UNITED STATES PATENT AND TRADEMARK OFFICE

Office Action Summary	Application No. 10/708,928	Applicant(s) HINSON ET AL.	
	Examiner Jeffrey Sharp	Art Unit 3677

DETAILED ACTION

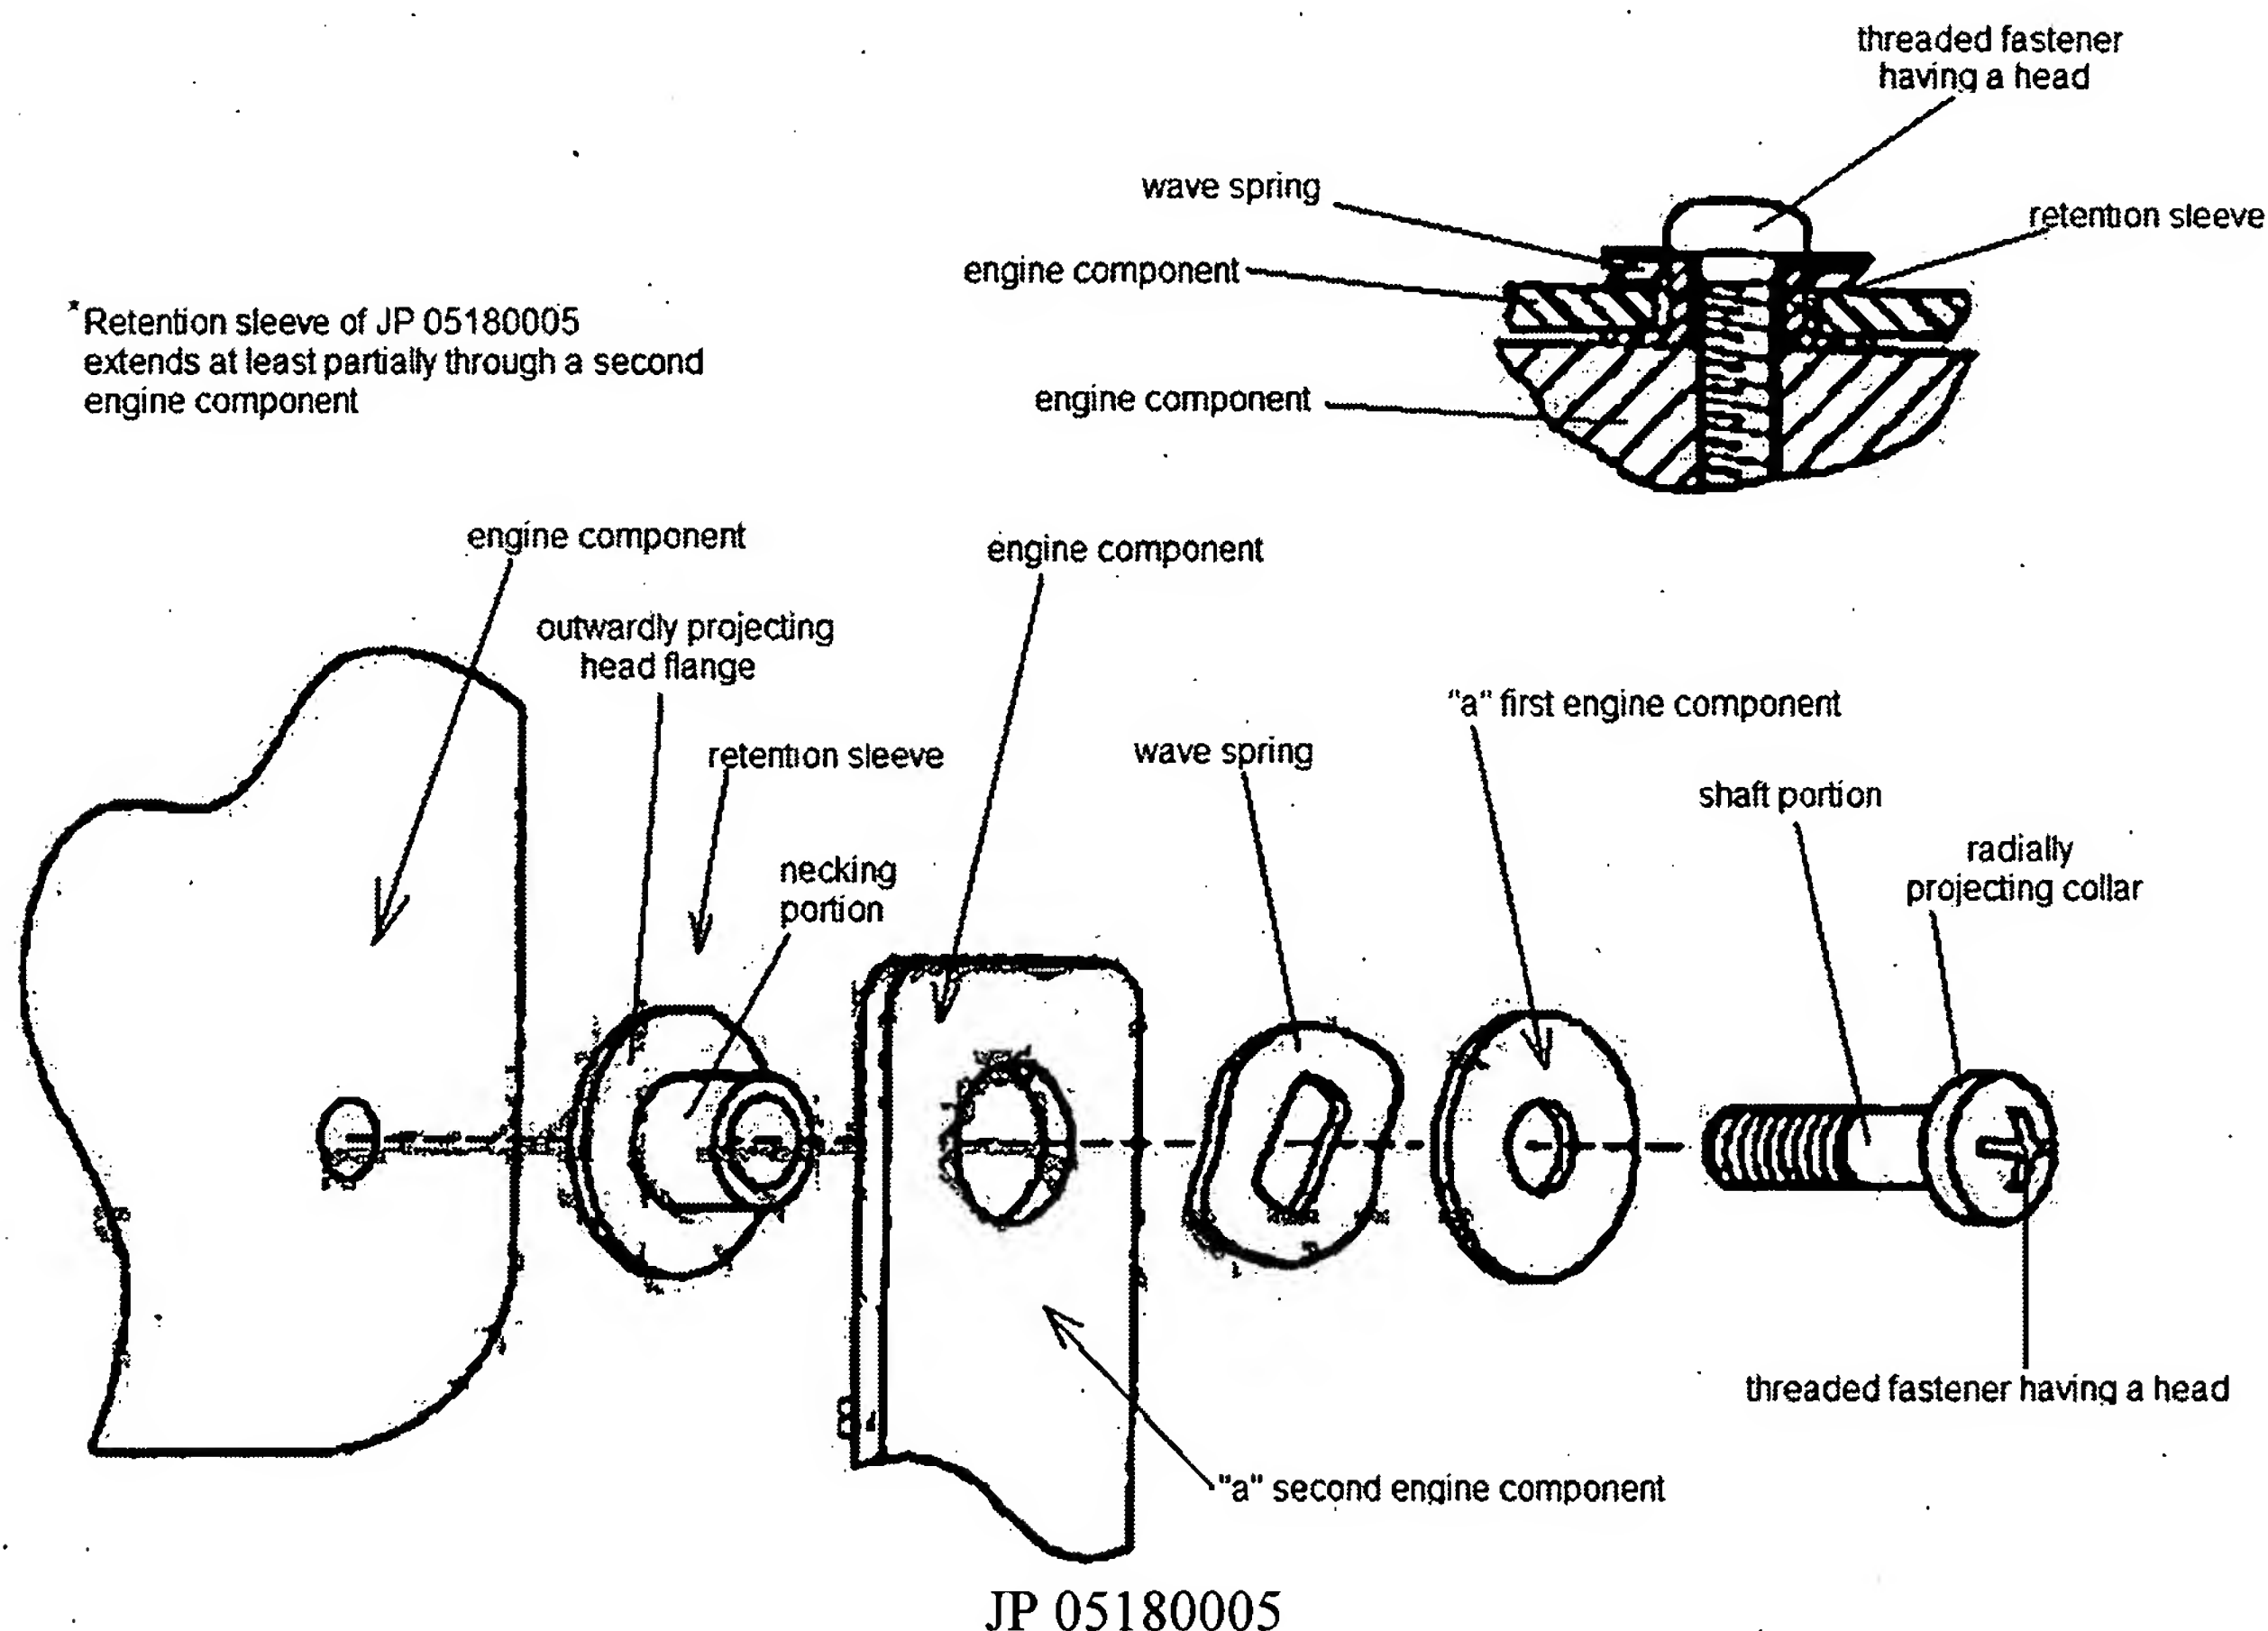
[9] As they are understood, claims 1, 3-8, 11, and 12 are rejected under 35 U.S.C. 102(b) as being clearly anticipated by, JP 05180005. See annotated drawing below. JP 05180005 teaches or suggests, a retention sleeve (10b), wave spring (10c) disposed about the retention sleeve

(10b), and a threaded fastener (10e) extending therethrough. The fastener assembly taught by JP 05180005 "generally" forms a seal between engine components (3) and (10). The examiner takes the position that no engine components are positively claimed. As for claims 11 and 12, JP 05180005 shows at least two fastener assemblies in Figure 5.

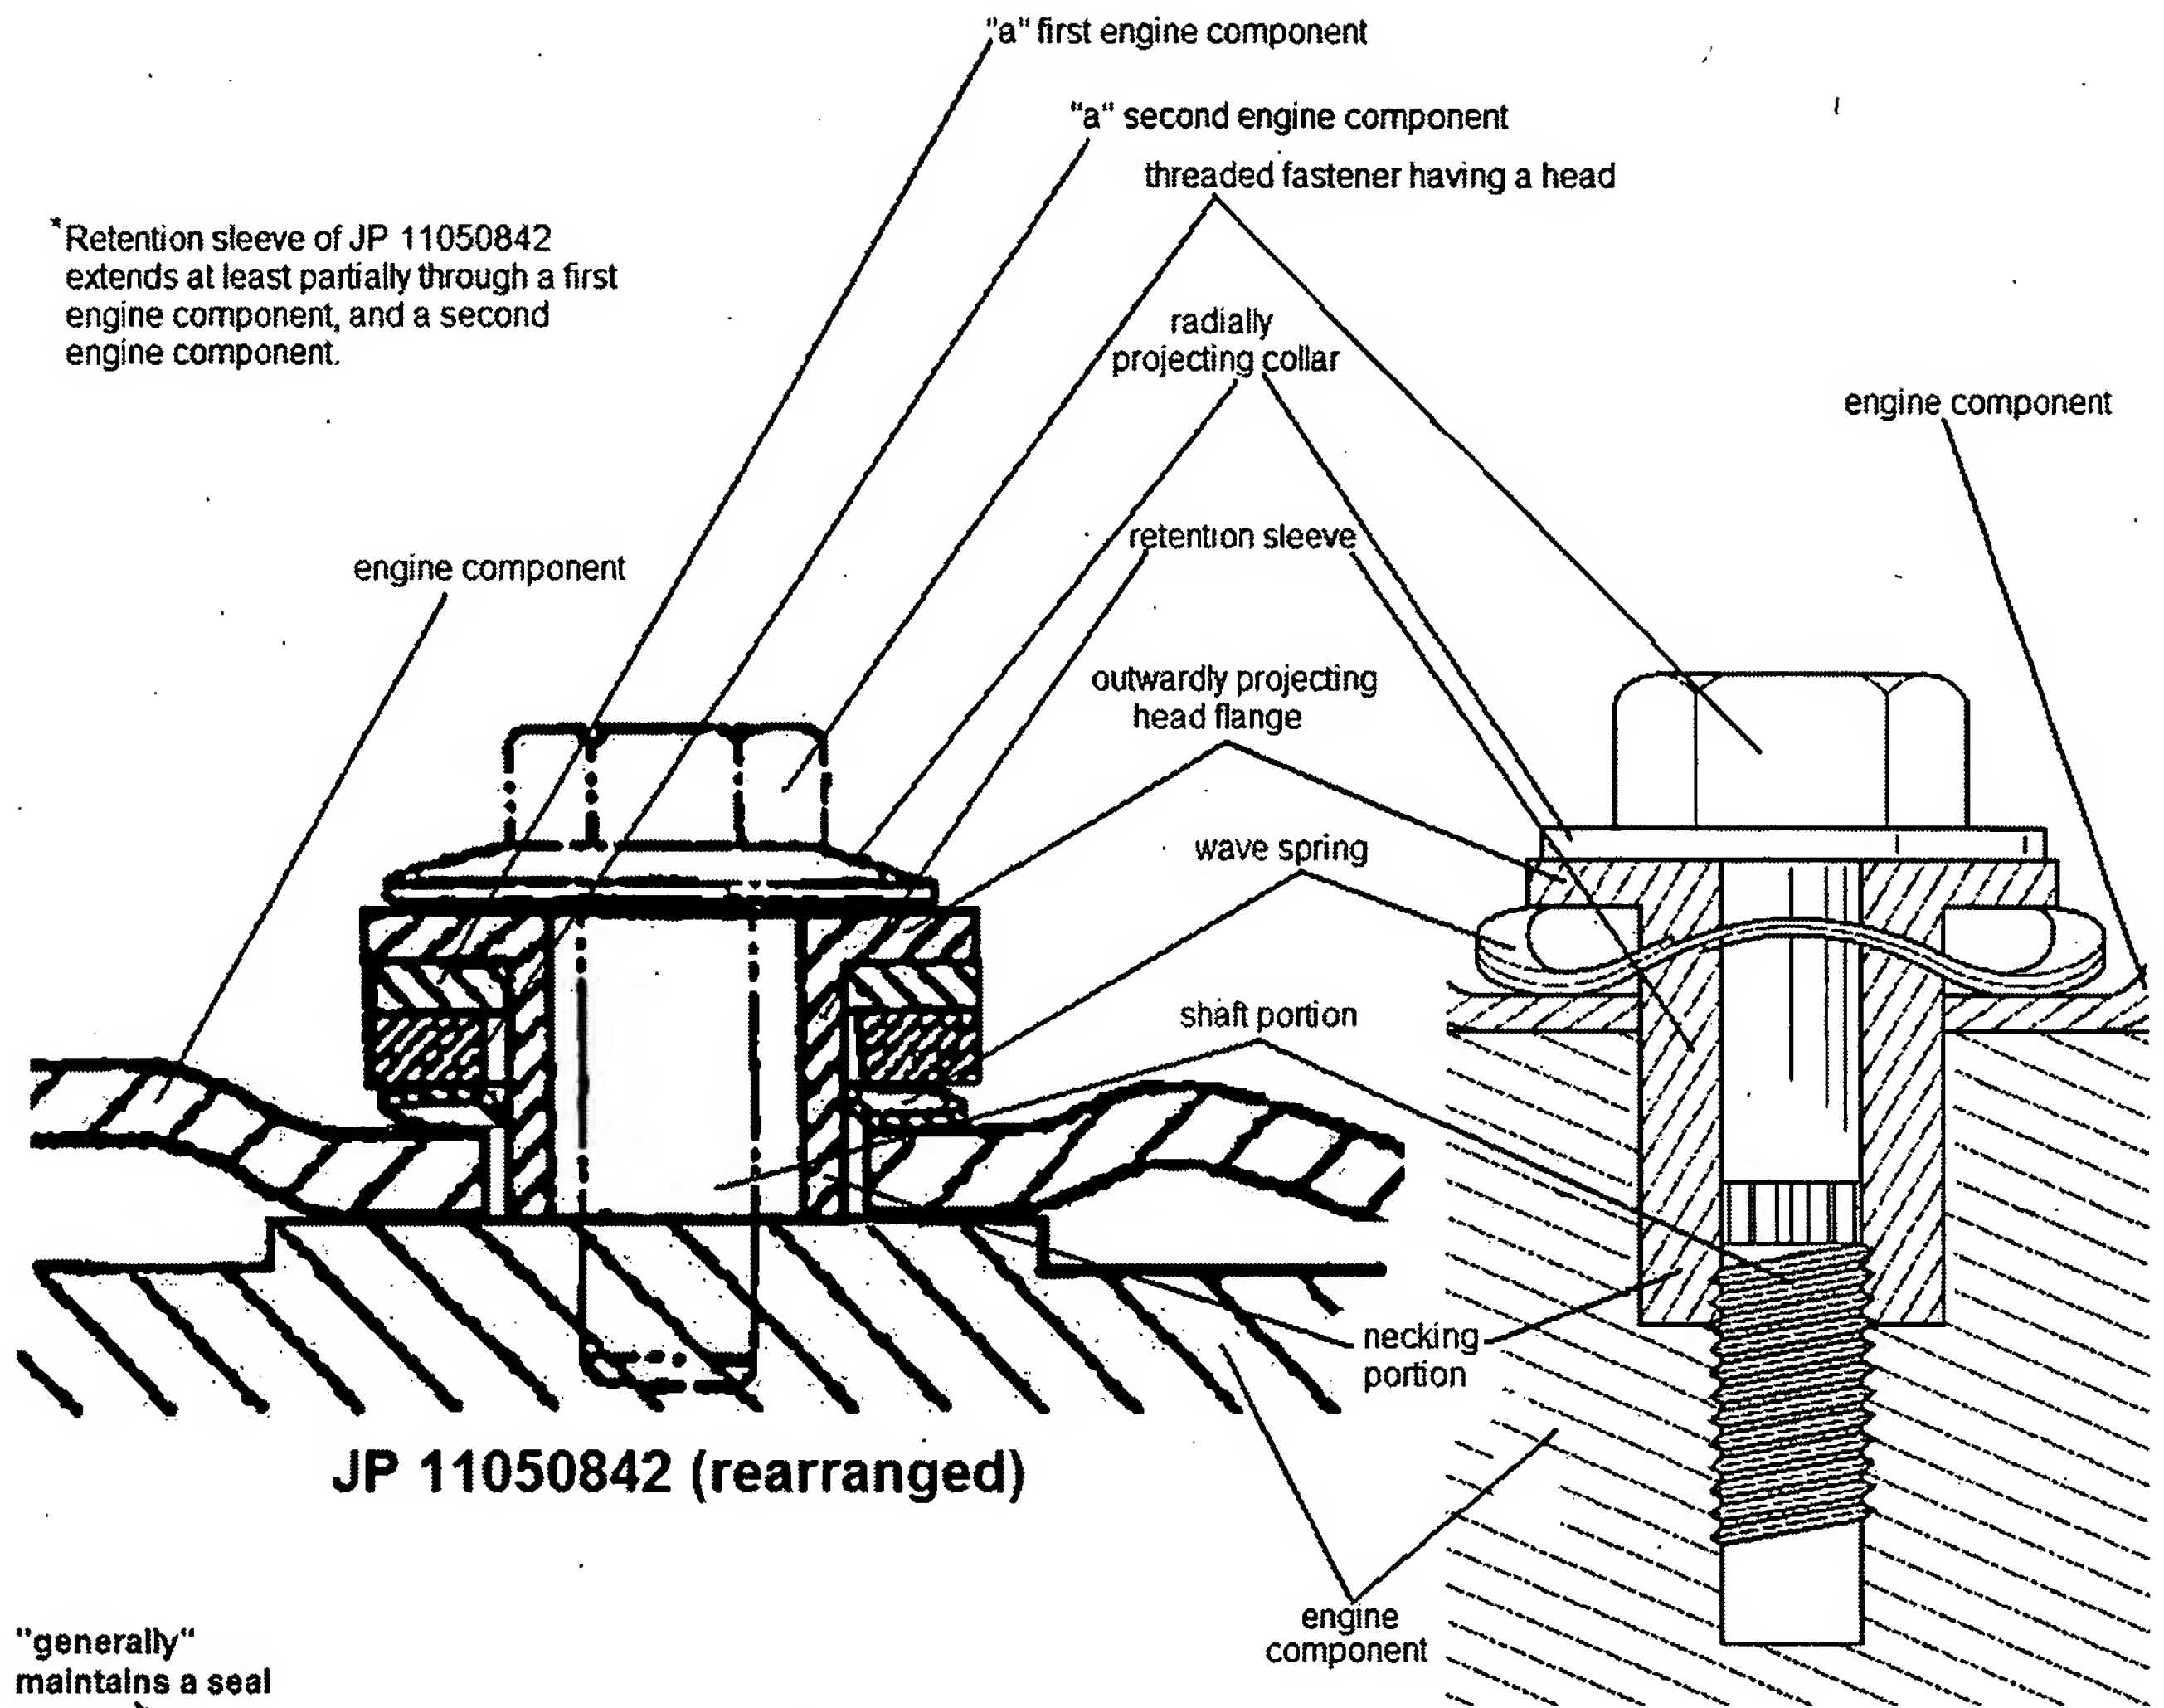
*Pertinent to claims 11 and 12, Figure 2 of JP 11050842 shows multiple fasteners and wave springs to acoustically decouple two engine components.

Applicant does not positively claim "a first engine component" or "a second engine component". However, JP 11050842 still shows in its broadest reasonable interpretation, "at

least a portion of the retention sleeve selectively extends at least partially into an aperture formed in a first engine component (3a)" and "at least a portion of said retention sleeve selectively extends at least partially into an aperture formed in a second engine component (1 or 5)".

As for the limitation "while generally maintaining a seal therebetween", Applicant does not positively claim that the "seal" of the present invention comprises. Applicant argues that mesh (5) does not create a seal because it is not essentially airtight or watertight. However, the limitation "seal" is not limited in the claims in such a manner. The examiner takes the position that the component 5 creates a "seal" against highly viscous fluids and large solid contaminants. Flange (3b) and wave spring (6) further create a (broad) "seal" between engine components (1) and (2).

Schmidt, Jr. US-5,711,711

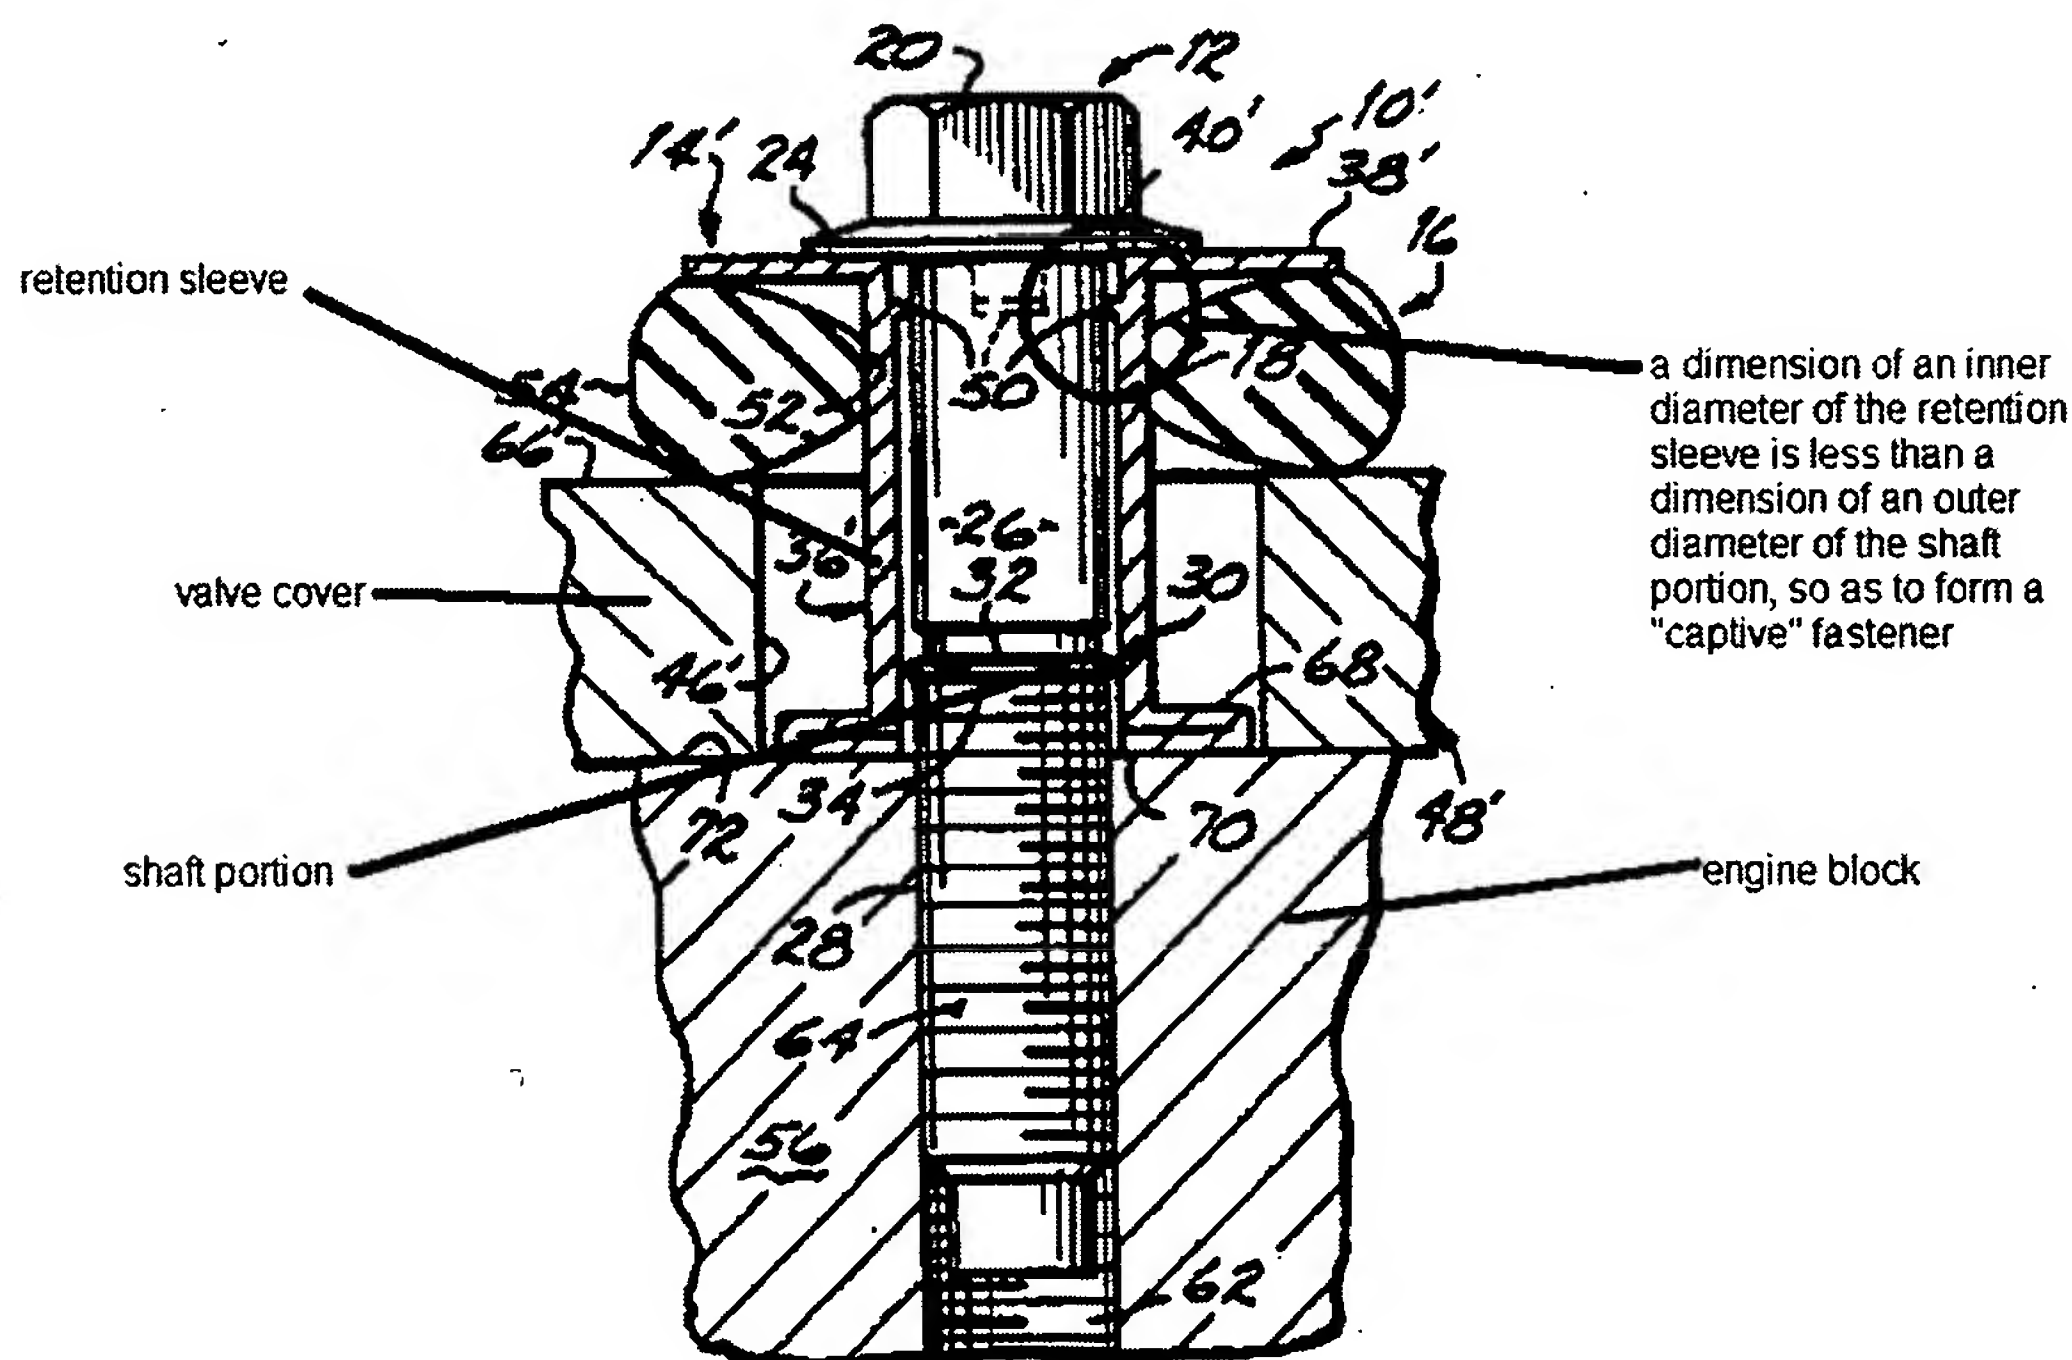
Schmidt, Jr. suggests a fastener assembly for mounting an upper workpiece to a lower workpiece, and mentions an application where it could be advantageously used to mount a valve cover to an engine block. This would suggest to one of ordinary skill that fastener assemblies, in general, could be used to join valve covers and engine blocks as an *intended use* of the fastener assembly.

Schmidt, Jr. also suggests a retention sleeve having an inner diameter smaller than an outer diameter of the threaded fastener shaft, in order to keep the two parts from separation. One of ordinary skill in the art would further appreciate that this fastener "sub-assembly" may also help reduce manufacturing costs, reduce assembly time, and prevent inadvertent loss of the bolt(s) when the valve cover is taken off. It has been held to be within the general skill of a worker in the art to make plural parts unitary as a matter of obvious choice. *In re Larson*, 144 USPQ 347 (CCPA 1965); *In re Lockart*, 90 USPQ 214 (CCPA 1951).

Therefore, at the time of invention, it would have been obvious to one of ordinary skill in the art, to modify the respective diameters of the fastener shaft and retention sleeve taught by JP 11050842 such that the retention sleeve has an inner diameter smaller than that of the fastener shaft as suggested by Schmidt, Jr., in order to achieve any or all of the abovementioned advantages.
